CITY OF GARDEN CITY

STAFF REPORT
File Number: SUBFY2024 - 0006, Edgemere Subdivision
For: Combined Preliminary and Final Plat and Planned Unit Development
 An 8 residential and 1 common lot subdivision
Location: 219 E. 44th Street
Applicant: Jadon Schnider
Report Date:
Design Review: May 19, 2025
Planning & Zoning: November 19, 2025
City Council: February 23, 2026

Staff Report
 Report prepared by Hanna Veal

Figure 1: Aerial image showing adjacent parcels. 225 E. 44th Street contains two homes which will also utilize the proposed private drive of the development. (10 dwelling units being accessed off the common drive).

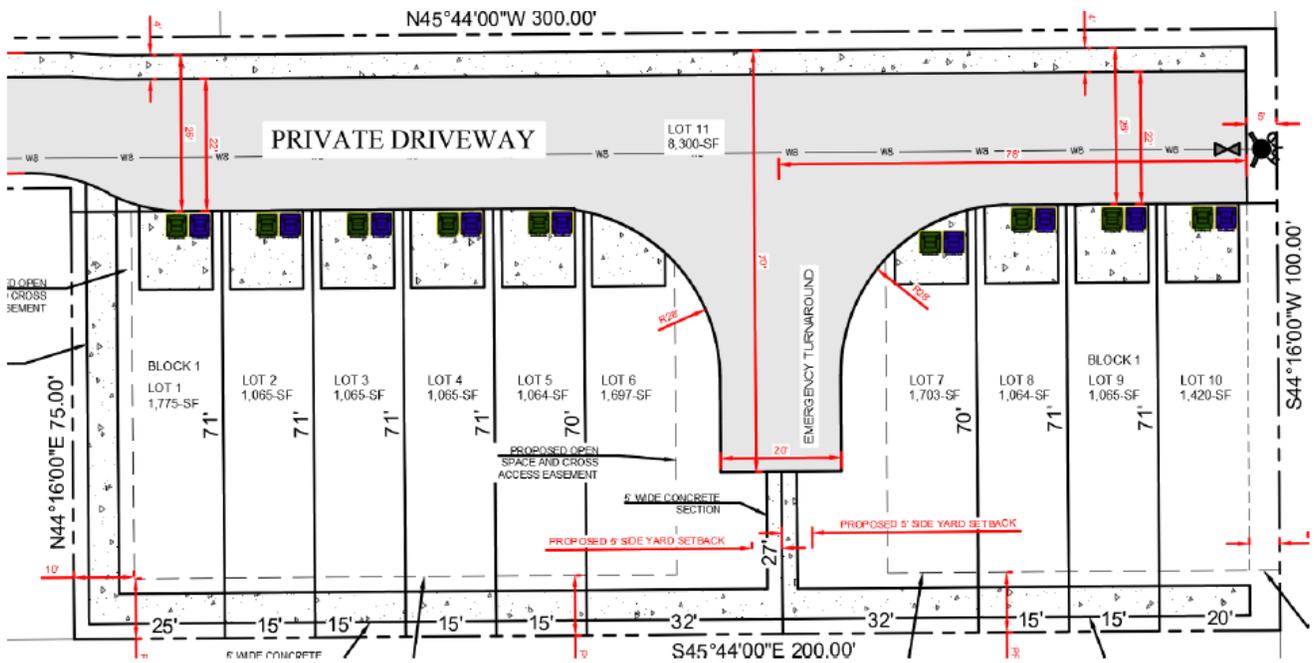
Staff recommends classifying the proposed access as a common drive rather than a private street. This approach is consistent with previous discussions with the Council and better reflects the physical characteristics and intended function of the access. The driveway meets the minimum width requirement of 20' and complies with surfacing standards for fire apparatus, which aligns with the design expectations for a common drive. While Garden City Code 8-5A-5D limits common driveways to four dwelling units, this restriction can be addressed through the Planned Unit Development process. The applicant has expressed willingness to pursue this classification and requests a code adjustment to allow 10 units (proposed and existing) to take access from the shared common drive. [See Images.](#)

Staff strongly recommends that the private drive be constructed and paved to the eastern property boundary, with provisions for future connectivity³, such as cross-access easements and references in the CC&Rs, are incorporated into the final design. Doing so will allow the development to better align with the [Old Town Circulation Network Plan](#), which identifies a micro street connection in this location. This recommendation directly supports Comprehensive Plan Goal 7: Connect the City, particularly its objectives to discourage cul-de-sacs and strengthen neighborhood interconnectivity.
